**WHEELING PLAN COMMISSION
THURSDAY, SEPTEMBER 14, 2017 6:30 P.M.**

**AGENDA FOR A REGULAR MEETING OF THE PLAN COMMISSION
to be held in the Board Room of the Village Hall
2 Community Boulevard, Wheeling, Illinois**

REQUEST FOR PLAN COMMISSION ACTION
STAFF PROJECT REVIEW

[Floor plan](#)

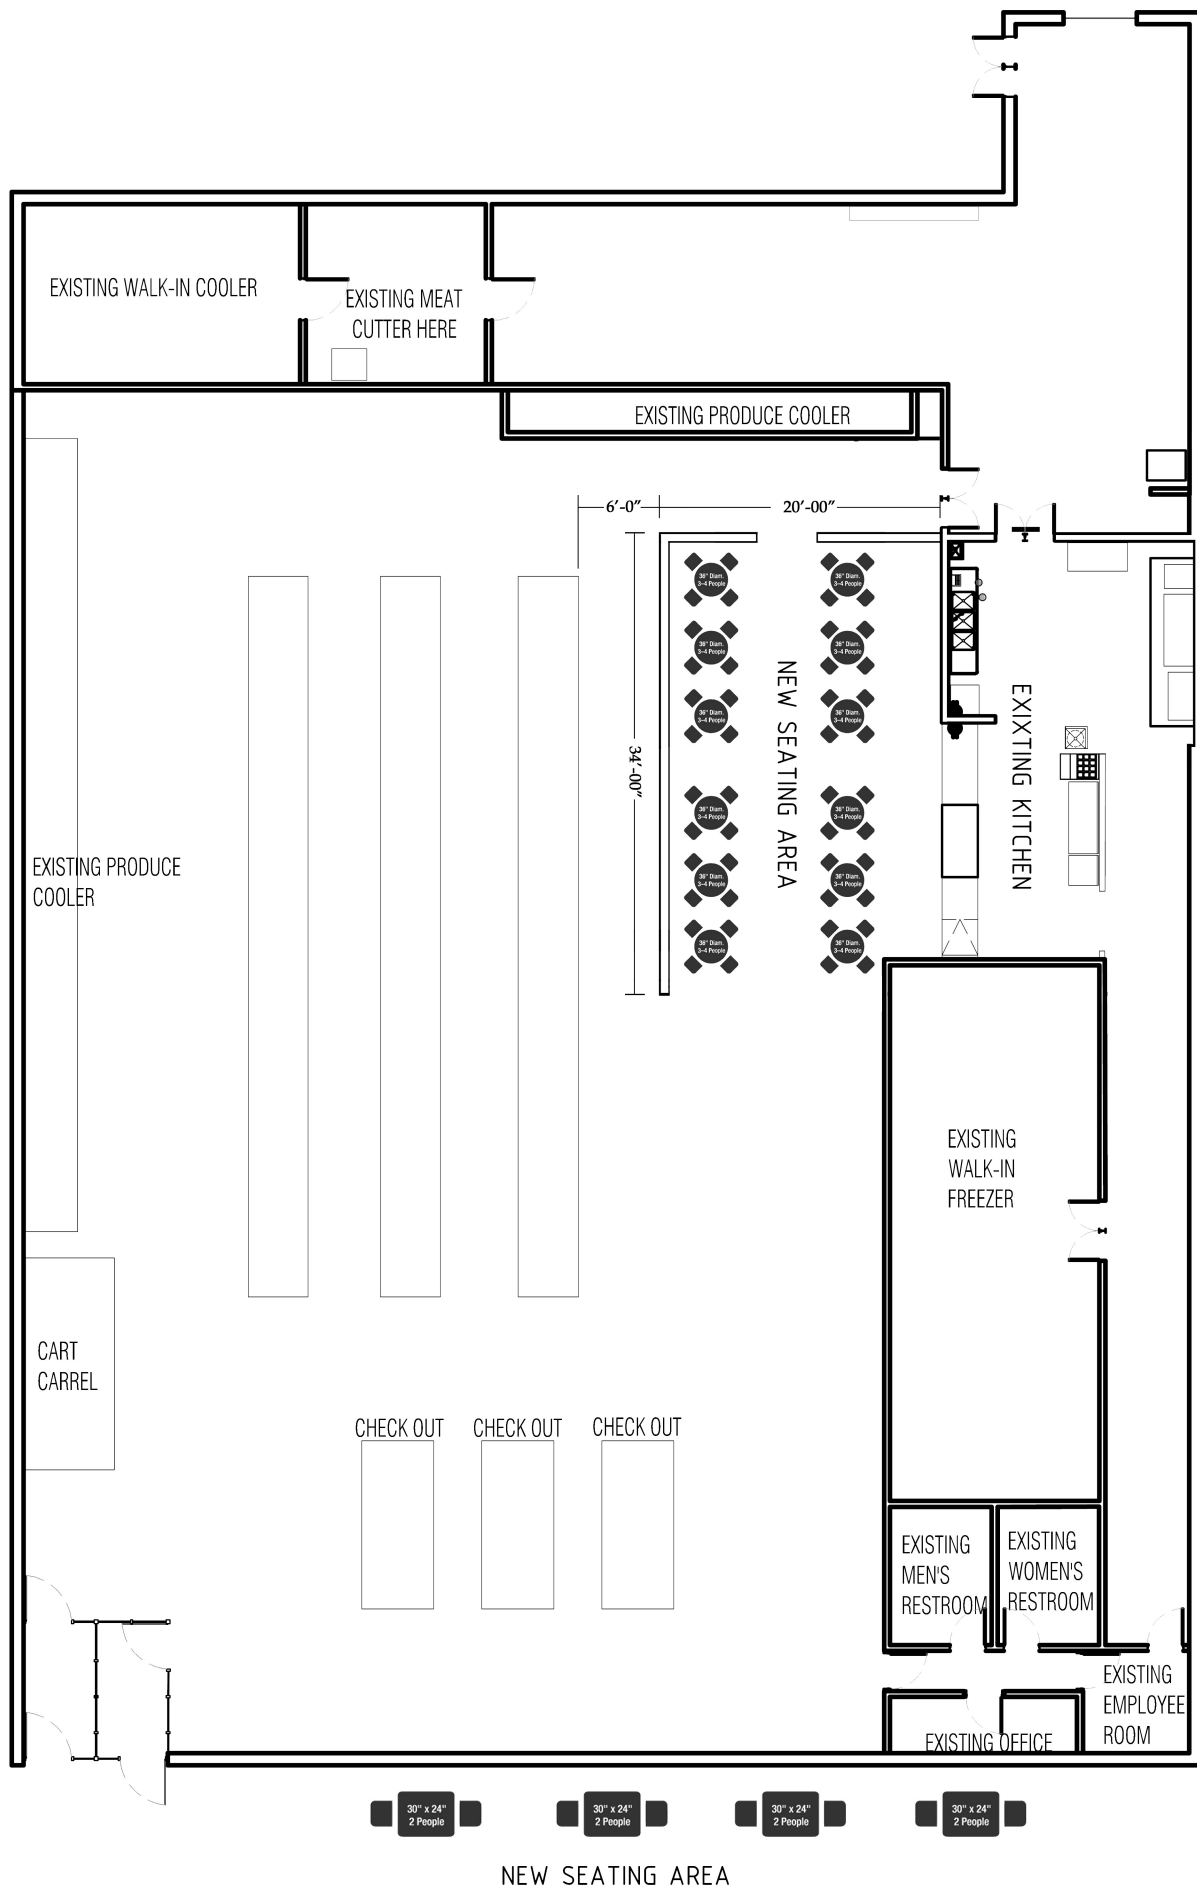
Floor Plan: No structural changes are proposed. A 20-foot by 34-foot seating area will be partially walled off to create a café space for seating. 48 indoor seats are proposed for this space. The dine-in customers will order food from the existing kitchen space, which is located adjacent to the indoor seating. Outdoor dining for a maximum of 10 seats is also proposed.

Trash: Existing trash enclosures are located at the rear of the site along the rear service drive. The Plan Commission may wish to require an additional trash can for the outdoor dining. Staff has added a condition of approval to the motion to address this issue.

1. That a trash can be added to the outdoor seating area.

ARCHITECTURAL SITE PLAN

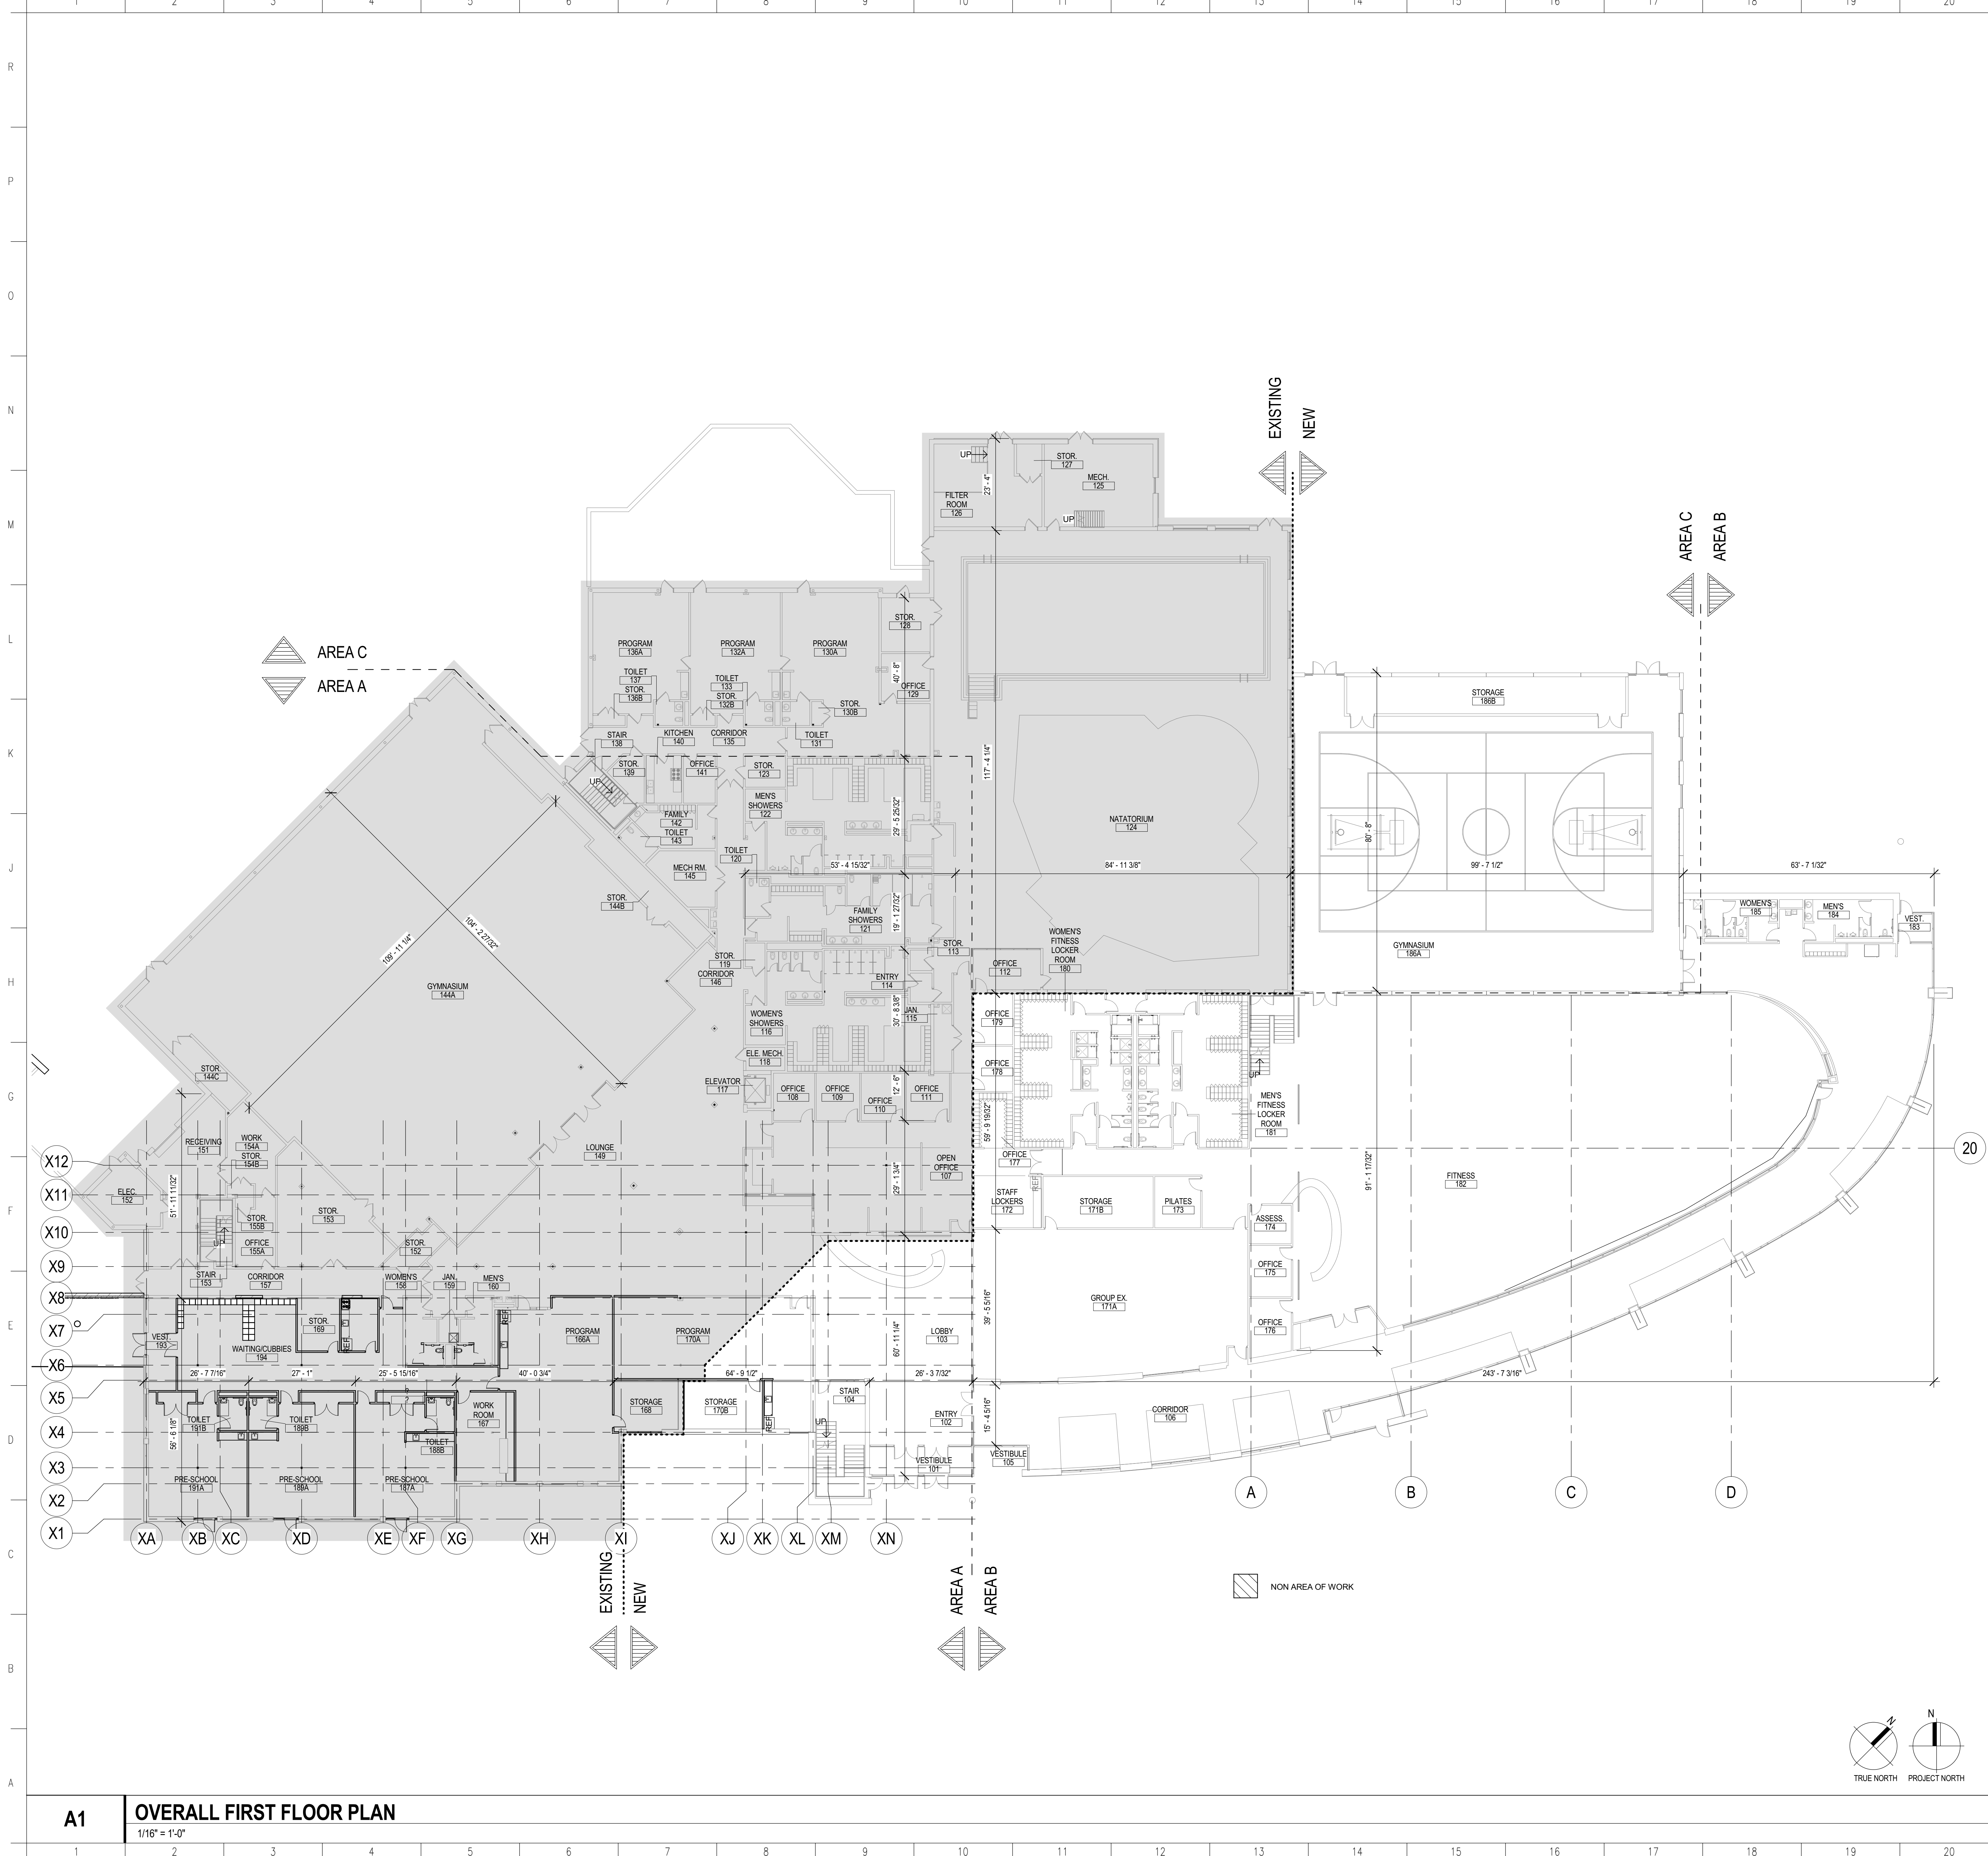
Proposed General Site Layout: A two-story building addition is proposed for the northeast corner of the existing building. A new sidewalk will be added around this portion of the building. However, no change is proposed to the existing access drive from Community Drive or to the existing parking lot just east of the building. The outdoor play space for the preschool, which is currently found at the west side of the building, is being relocated to the south end of the building. Adjacent to the outdoor play area and preschool entry will be a new 10-stall parking area.

Total Number of Parking Spaces: As part of this project, 10 additional parking spaces will be added to the southwest corner of the building. These spaces will be likely utilized by the relocated preschool, which currently has an entry on the west side of the building. A parking exhibit has been provided by the petitioner that identifies parking throughout all of Heritage Park. The exhibit notes a total of 716 spaces and a parking requirement of 676 spaces. Therefore, with the proposed building and site modifications, the parking requirements of the Zoning Code will be exceeded. However, due to the expansion of the CRC space and programs it is conceivable that there will be additional parking demand near the CRC. Instead of building those spaces now, both the Park District staff and Village staff agree it would be prudent to observe how the existing parking and 10 new spaces will be utilized after the CRC construction and the Town Center construction is complete. Members of both staff would like to study the future auto traffic flows, pedestrian patterns, and utilization of building entries, and install additional parking, only if deemed necessary. The addition of future parking would necessitate site plan and appearance review by the Plan Commission.

1. The site plan reviewed includes a 42,207 +/- square foot addition to an existing recreational facility.
2. The existing building has a fire apparatus access route around the building that would serve that building and the addition. The only modification associated with the existing access route is the revised drive and parking areas at the southwest corner of the building.

- a. This change does not affect the Fire Department's ability to access the building.
 - b. This change may have an impact on the Fire Department's ability to access the existing Fire Department Connection (FDC) located in this area and will require further review during the permitting process..

SHEET NO.
A3.1.0-2

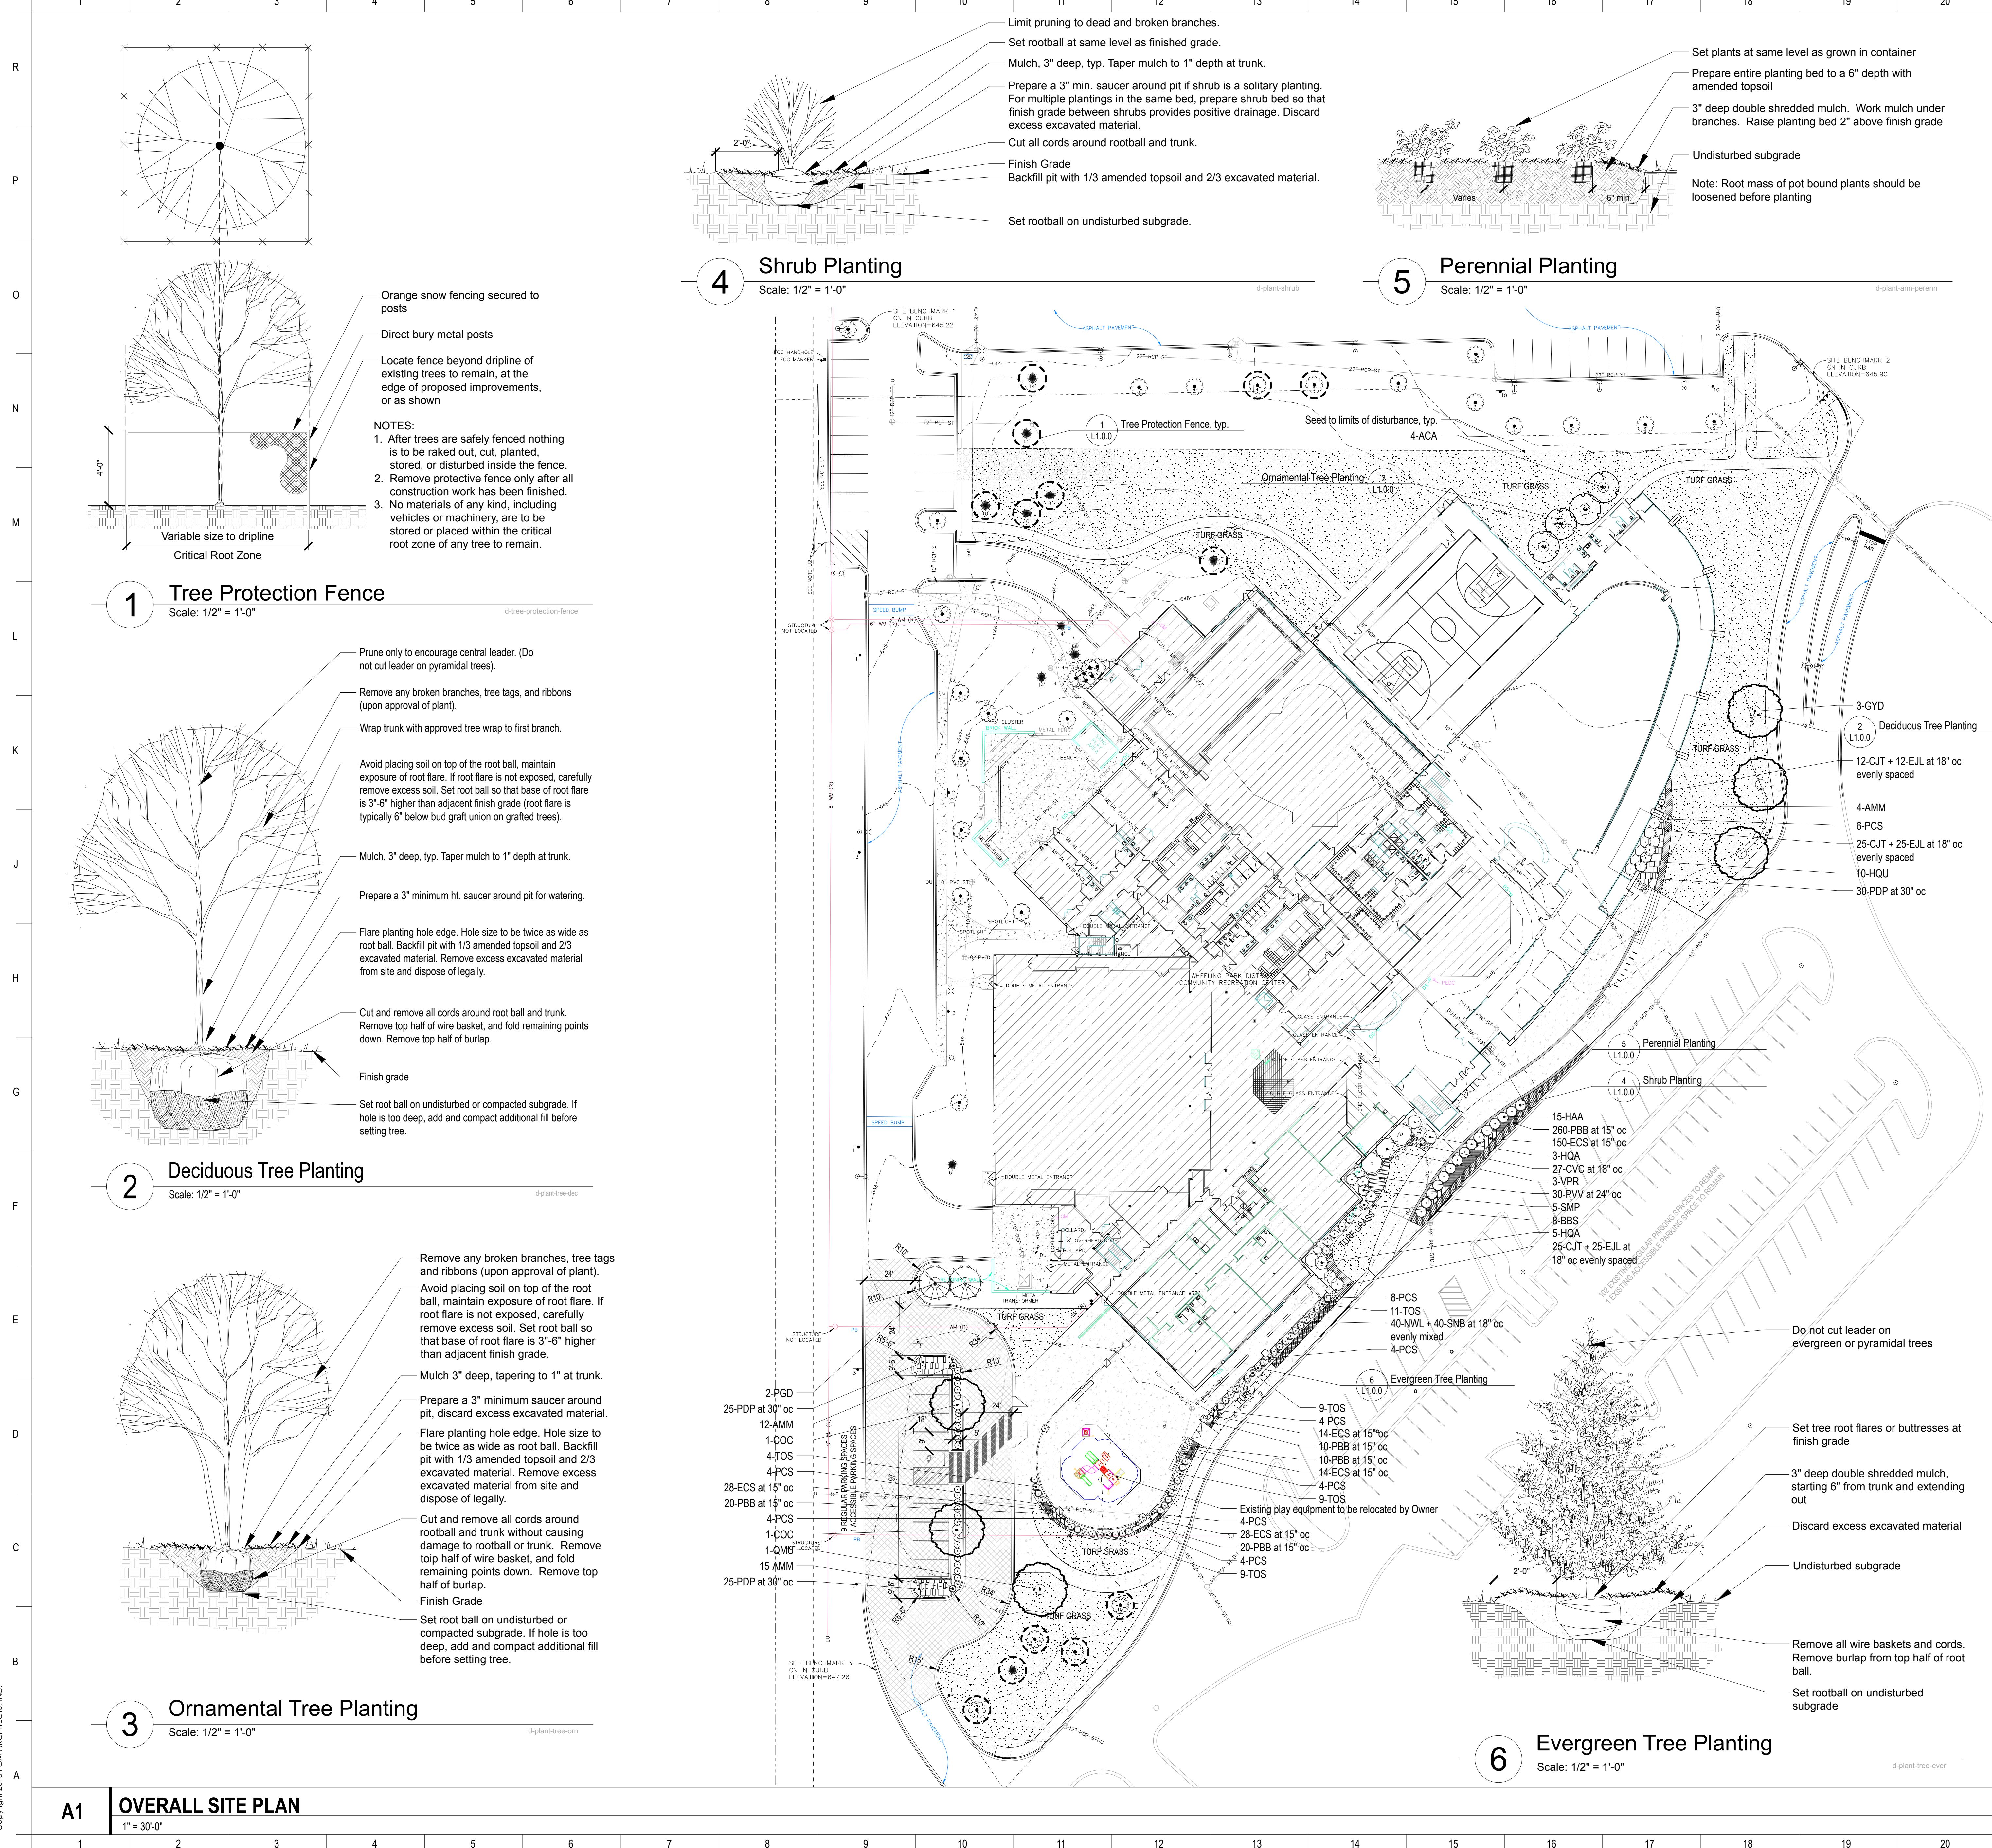
Elevation Plan Review: Elevation plans are provided on Sheet A3.1.0-2.

HVAC/Mechanical Components Screened: The elevation plans indicate "gray roof top unit screens."
